## > Product Change Notification (PCN)

<b>Product group:</b>	<b>SEMIPACK</b>	<b>Rev.:</b>	<b>0</b>
<b>No.:</b>	<b>PN22-063 SEMIPACK 3 new material of the cap insulator</b>	<b>01 Jun 2022</b>

**Subject of change:** Introduction of a new material for the cap insulator

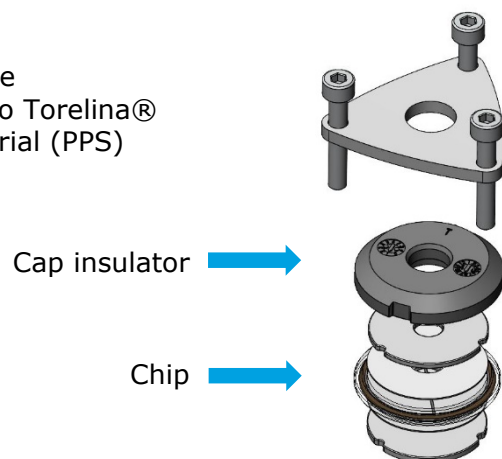
**Description of change:** Change of the material of the cap insulator from Ryton® to Torelina®  
No change of the base material (PPS)
